EXXEL PACIFIC
GENERAL CONTRACTORS

Request For Information - 152

The Cora Apartments (19 W Harrison)

Subject:	**Unit 203 Restroom Sink**	**Status:**	**Open**
Drawing #:	A202	**Spec Sect #:**	JGID Plumbing
Addendum:		**Submittal #:**

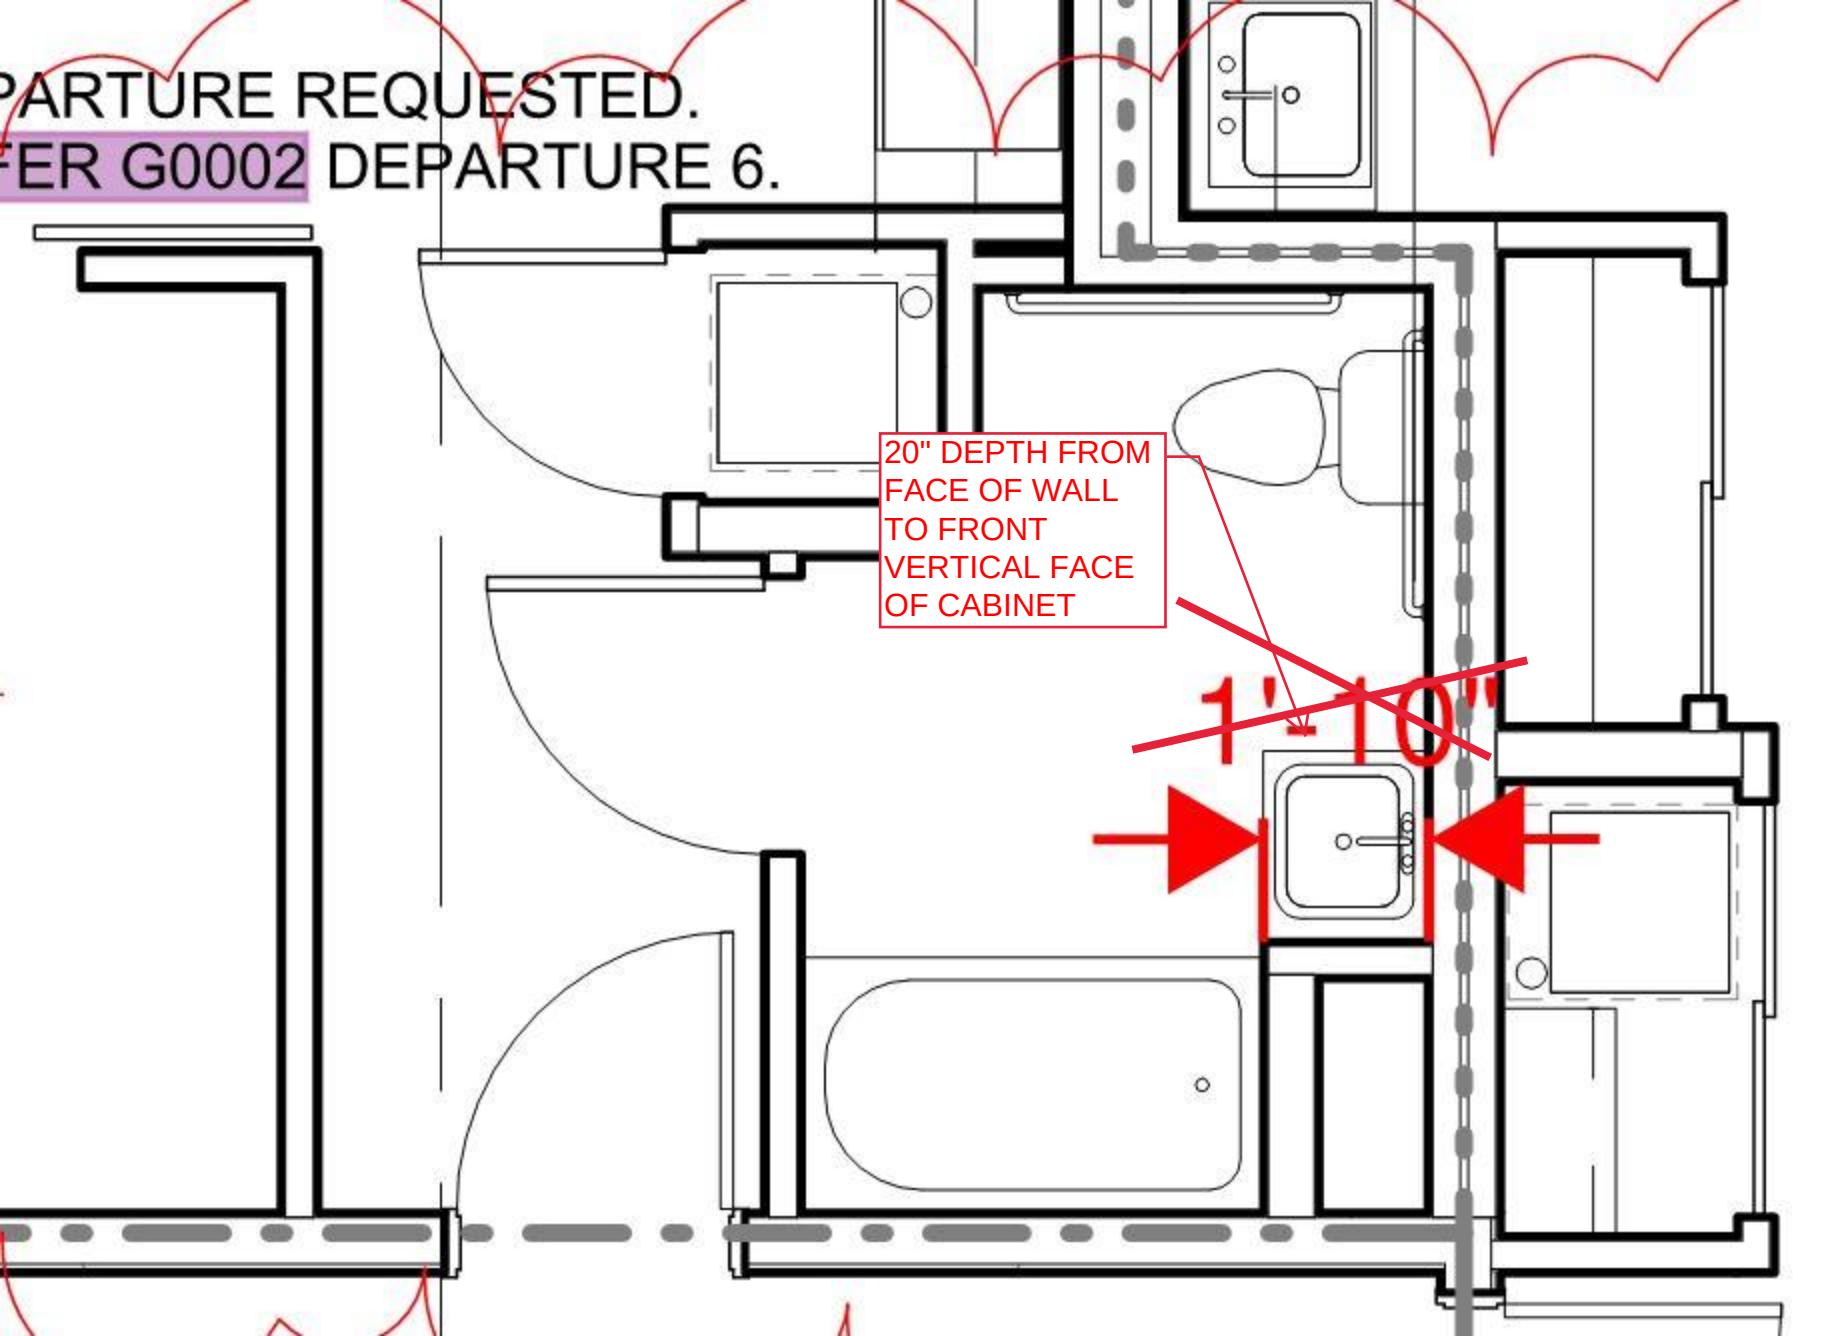
The restroom layout in Unit 203 places the lavatory at the adjacent wall to the tub. The chase wall leading to the tub is 20" per plan. All other unit restrooms use a 24" deep countertop.

Unit Restroom Lavatories are 16 3/8" deep.

The current layout would leave a very tight fit for all plumbing fixtures to be installed within the depth of the countertop to match the depth of the chase wall.

Please advise a desired dimensioned layout for the current sink model, or specifiy a new sink type to be used in this unit.

Date	Response
5-22-17	SEE ATTACHED PROPOSED SINK FOR UNIT 203 20" DEEP SINK CABINET CONDITION.

PARTURE REQUESTED.
FER G0002 DEPARTURE 6.
20" DEPTH FROM FACE OF WALL TO FRONT VERTICAL FACE OF CABINET
1'-10"

L-1 TYPE B LAVATORY

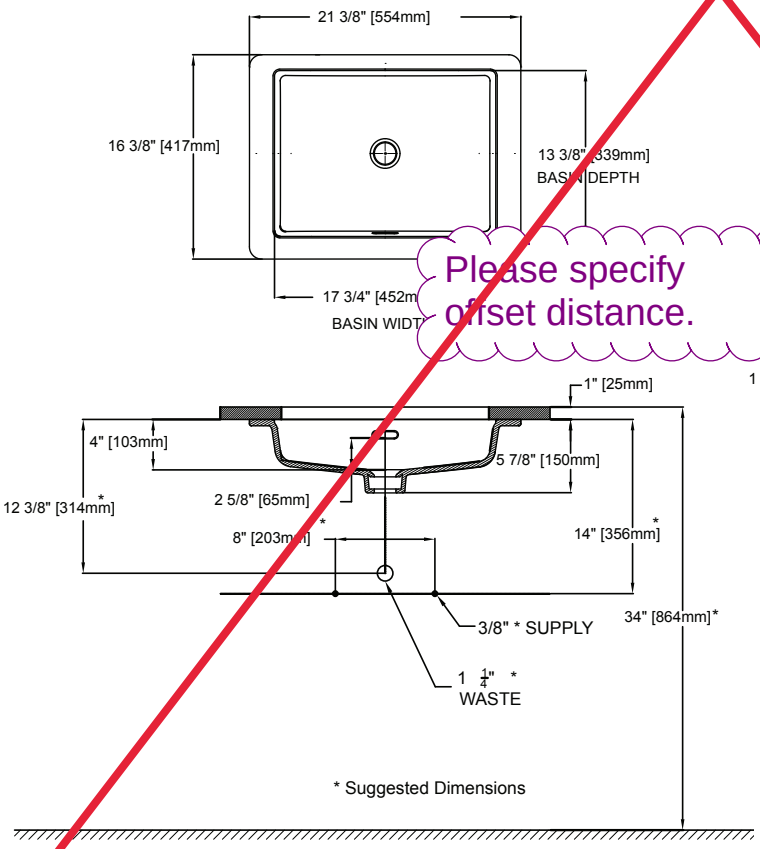
JGID: DO NOT USE IN UNIT 203 BATHROOM CABINET ADJACENT TO CHASE

Please specify offset distance.

20" in Unit 203
